# MONTGOMERY COUNTY HISTORIC PRESERVATION COMMISSION STAFF REPORT

Address: 23717 Woodfield Road, Gaithersburg Meeting Date: 8/14/2024

Case No.: 1067618 Staff: Laura DiPasquale

**Proposal:** Construction of accessory structure

Figure 4: Birdseye view of 23717 Woodfield Road (shown with the yellow star) and adjacent properties. Note numerous detached accessory structures with simple gable roofs located towards the rears of properties in the district. Source: ConnectExplorer, 2023.

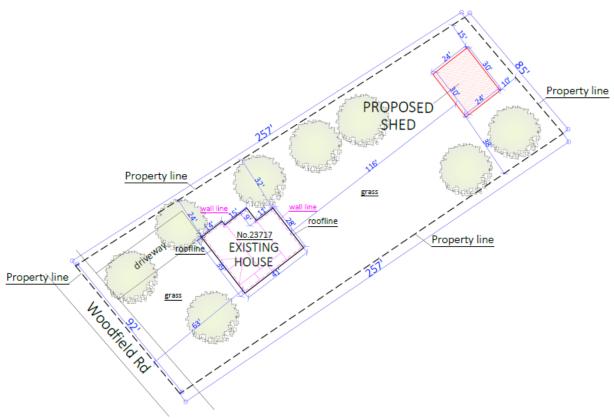
The property at 23717 Woodfield Avenue is 257 feet deep by 92 feet wide, with the existing 39-foot by 41-foot house set back approximately 63 feet from Woodfield Road (see Figure 5). The proposed accessory structure would be located an additional 116 feet behind the house, although it would be visible from Woodfield Road owing to the undeveloped land to the southeast of the property (see Figure 3).

Staff finds that, in accordance with the *Damascus-Goshen Historic Resources Master Plan Amendment*, the proposed accessory structure respects the rural streetscape of the Woodfield Historic District. The proposed accessory structure will not affect any mature trees, alter the orientation of the historic house to the road, or affect the modest scale of any architectural elements that front on the road. In addition, the proposed accessory structure will be at the rear of the subject property, which although visible across undeveloped land, reduces visibility and the impact on the historic resource and district.

# SITE PLAN 23717 Woodfield Road Gaithersburg, MD 20882 Parcel ID: 12-0093330 Lot area: 0.5 Acres Paper Size: 11"x17"

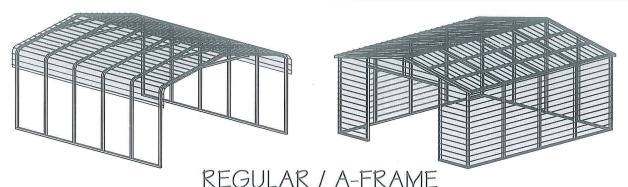
I am attaching a site plan done by a site plan company. I'm not sure why these trees are on the plan as I have no trees in the area where I want to put this shed. I am attaching pictures of the part of the yard where the shed will be. I have chosen a size of  $24 \times 30$ .

Thank you for sending the site plan. However, I need this on either your plat/site survey or another professionally prepared measured drawing. We also need photographs of this portion of the property and information about any trees that would be removed and any foundation that may be necessary. 25' x 30' is too large to qualify for staff approval; we can only staff approve buildings that are 250 square feet or smaller. So we will need to put this on the docket for a public hearing at the HPC when your application is complete. When you have chosen your specifications, please send those to me as well for the packet. Wood and metal buildings are common in this part of the County so I could see many choices being approvable. I am happy to look at any choice and give you a recommendation. When you have all the information and can send to me, I will let you know which docket the item will be scheduled for public hearing. Right now we are accepting items for the June 12th hearing. The schedule for public hearings and the due dates for materials for each meeting are available here on our website:
